URGENT - Field Safety Notice
MobileDiagnost wDR, Rel. 1 and 2

Protective safety cover is missing

FSN MA-FCO 71200159

2016-AUG-30

[Fig. 1]: Cover should be installed at this edge of the bottom

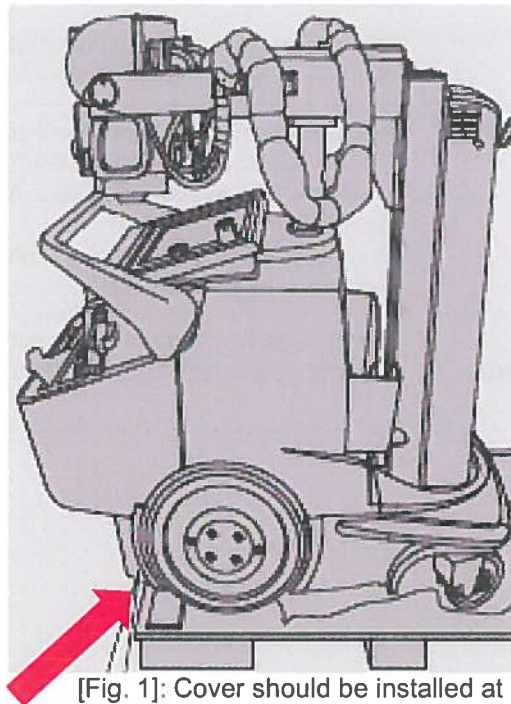
The customer / user should check if the protective cover is installed at the system.

[Fig 2]: If the cover is installed, the Engineer could not grab his fingers behind the front cover of the Mobile-System

<p>If the protective cover is <i>not</i> installed, please contact your responsible Philips representative. Please clean the affected area to prevent an issue of dirt or dust inside the system.</p> <p>If the protective cover is installed, the FCO is not necessary for your Mobile-System and the Mobile-System could be used as intended.</p>
ACTIONS PLANNED BY PHILIPS	<p>A Philips Service Engineer will contact you as soon as you contacted your Philips representative in case of missing protective cover. The protective cover is available for installation at your Mobile-System. This step will be done from a Philips Service Engineer.</p> <p>Should you need to communicate with Philips in regards to this program, please reference FCO-71200159.</p>
FURTHER INFORMATION AND SUPPORT	<p>If you need any further information or support concerning this issue, please contact your local Philips representative.</p>
